**MADDEN**  
**MOORHEAD & STOKES, LLC**  
**CIVIL ENGINEERS**

**RE: Lake Hills Residential Preliminary Subdivision Plan Resubmittal**

**TMH CONSULTING, INC.**

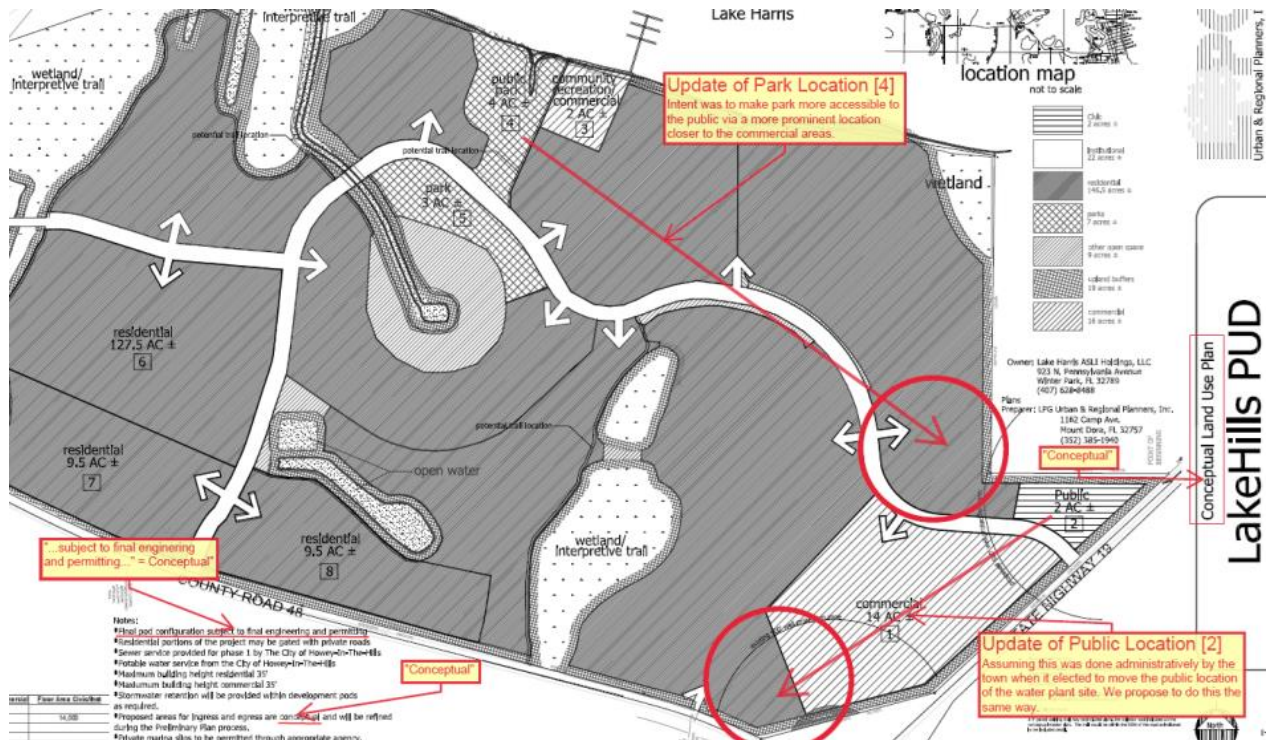
The four-acre public park is assigned to Pod 4 on the approved conceptual land use plan for the project. The current proposal to place the park in the area outside the control gate moves the park away from the Pod 4 designation. I think this is going to mean a modification to the most recent plan to move the facility back to the Pod 4 area.

***Response SC: The design intent is to provide the required 4-acre park is to locate it in a more prominent location than on the "Conceptual" Land Use Plan. The proposed location will bridge the residential and commercial areas and have better public accessibility for Howey residents. We see this to be very similar to the adjustment made for Public parcel [2] for the water plant when the Town elected to move it to the corner of US 19 and CR48. In that case the Conceptual Land Use Plan was not updated to make that change and these evidences the Towns understanding and application of the conceptual basis of this plan. We request to consistently follow what was done there.***
